Proposals by National Highways to Improve Pedestrian Crossing of the A36 at Pipehouse and Church Lane/Midford Lane Junctions

Nick Stevens

Pipehouse Lane Proposals

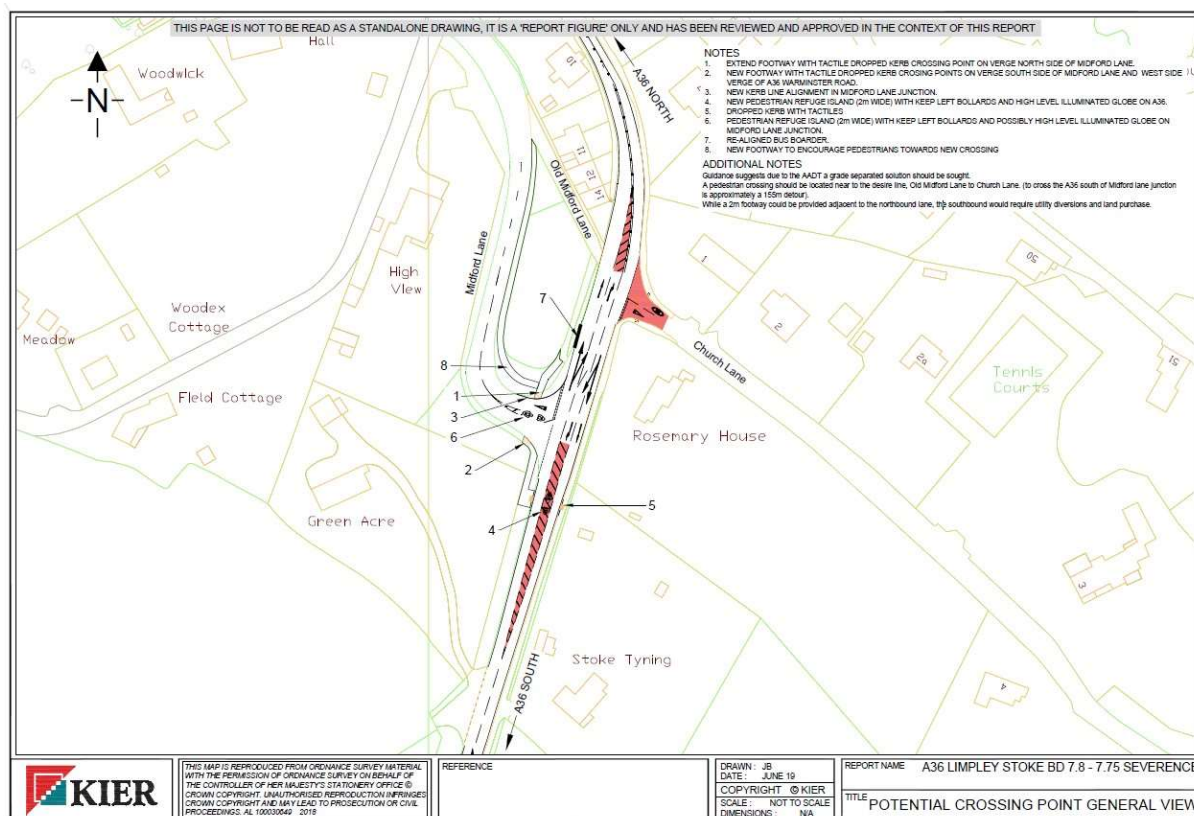
The comment shown on the plan that "It should be noted the A36 AADT (Annual Average Daily Traffic) exceeds value that at-grade informal crossing is normally considered appropriate the NSL (National Speed Limit) stopping sight distance 215 m." is not entirely clear in its meaning but seems to suggest that an informal crossing point is not considered

an appropriate option given the sight distances and the existing speed limit of 60 mph. While the sight lines are reasonably good at the Pipehouse junction the fact remains that vehicles travelling at 60 mph will travel 27 metres per second (89 feet) so will cover the distance of 215 metres in some 8 seconds. Stopping distance at 60mph is 73 metres (240 feet). Since traffic can be approaching the junction at that speed from both directions it requires pedestrians to remain extremely vigilant in assessing whether or not it is safe to cross the road.

The speed limit should be reduced from 60mph to 40 mph. Freshford PC has long pressed for a reduction of the speed limit along this stretch of the A36 to 40mph and if residents crossing the main road at this point are to use the improved footways and crossing points with confidence then there is every reason to make the case for a 40mph limit.

National Highways should be made aware of the Section 106 Pipehouse development requirement that a new footpath is installed to run from Merchants Lane to the A36. The NH proposal should seek to ensure that the two schemes are complimentary to each other and merge together to form a coherent footway from the A36 to the Pipehouse hamlet. (See Appendix A)
